Lufttüchtigkeitsanweisung
Consigne de navigabilité
Prescrizione di aeronavigabilità
Airworthiness directive

HB 94-086

HORIZONTAL STABILIZER HINGE BRACKETS

INSPECTION OF - HORIZONTAL STABILIZER - HINGE BRACKETS.

Repair Detail
Figure 1

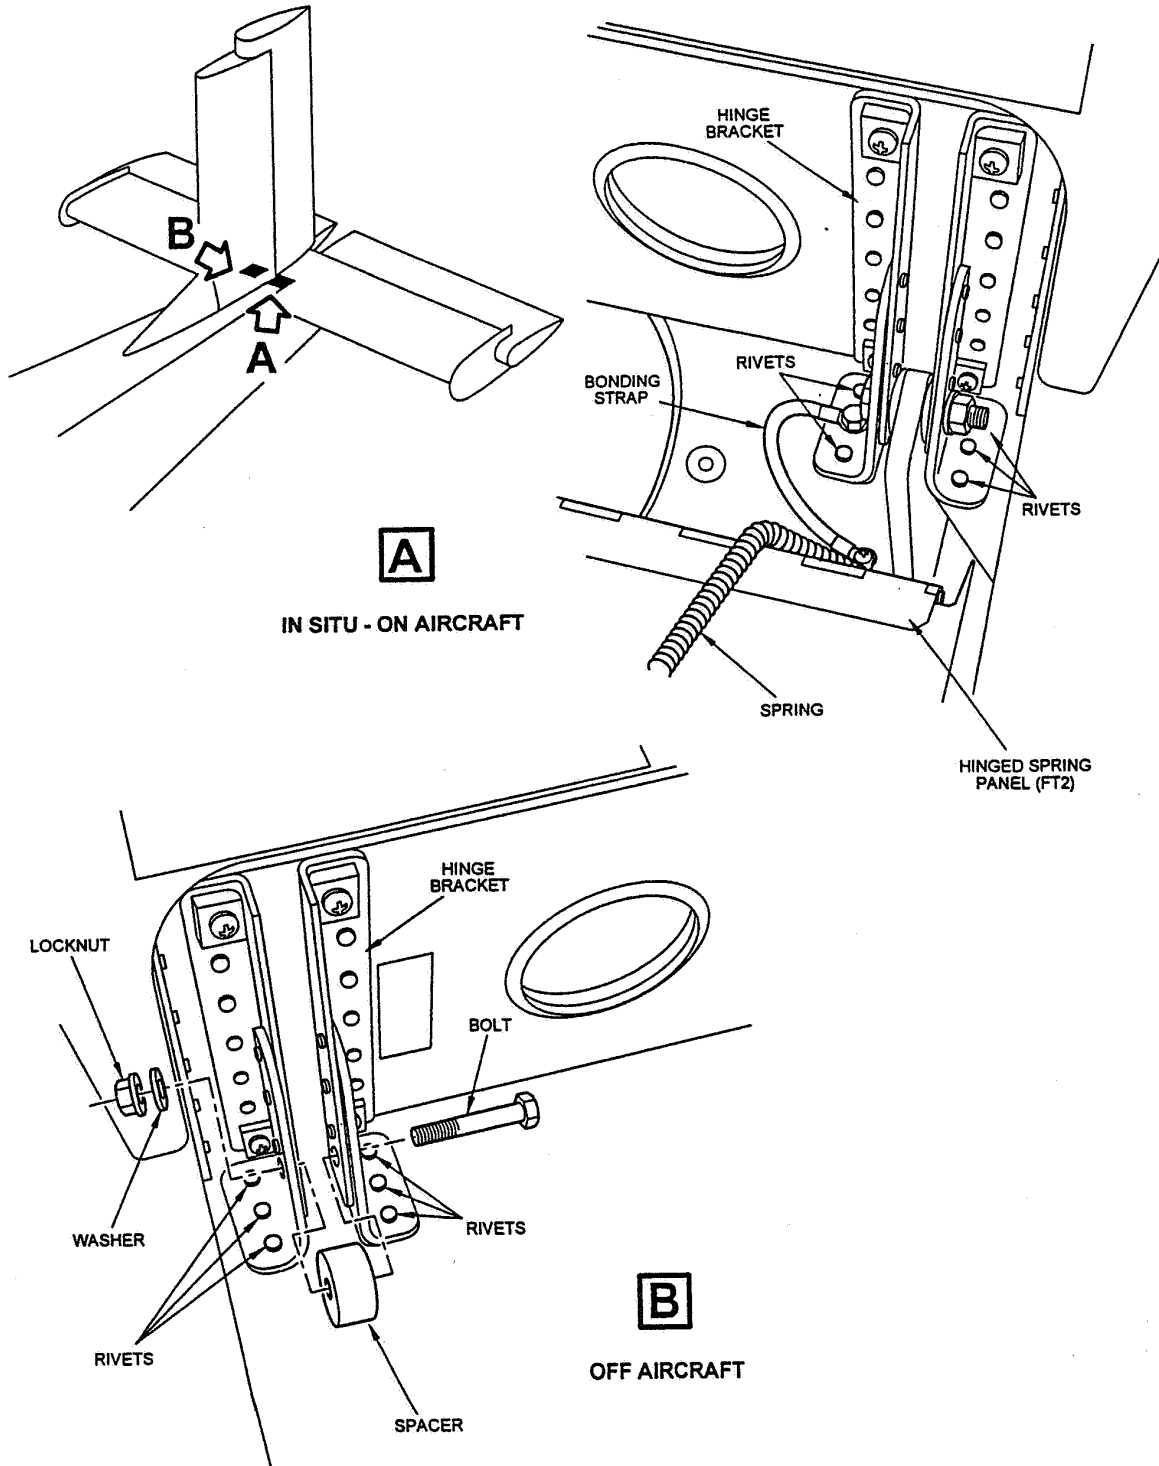
- (1) Lift the RH hinged-spring panel (FT3) and inspect the hinge bracket [6 rivets] (Ref. Fig. 1).

- (1) Lift the RH hinged-spring panel (FT3) and inspect the hinge bracket [6 rivets] (Ref. Fig. 1).

- (10) Insert the 15 mm spacer, as shown in Figure 1, Detail B, and secure in position with the bolt.
- (11) When inserting the spacer, note the amount of force required to position the spacer.

NOTE: The spacer should not be able to displace or deflect the bracket. Where any force is needed to position the spacer then the bracket must be re-positioned.

When either one of the brackets is found to out off tolerance, then both brackets must be re-positioned

- (1) Drill out all indicated rivets from the respective hinge bracket (Ref. Fig. 1).
- (2) Assemble the hinge bracket with the new spacer and secure together with the bolt, washer and locknut.
- (3) Torque-tighten the locknut to 14.7 Nm (130 lbf in).
- (4) Drill one hole in the hinge bracket and insert a grip pin.
NOTE: All holes to be drill 4.1 mm dia.
- (5) Drill out the opposite hole and insert a grip pin.
- (6) Drill all other holes.
- (7) Deburr, clean and restore surface finish (Ref. SRM 51-00-06)
- (8) Rivet the holes.
- (9) Remove both grip pins.
- (10) Deburr, clean and restore surface finish (Ref. SRM 51-00-06) of the two holes and then rivet.
- (11) Remove nut, washer and bolt and 15 mm spacer.
- (12) Repeat steps 1 thru 11 on the other hinge bracket.
- (13) Repair paint scheme (Ref. SRM 51-00-06).
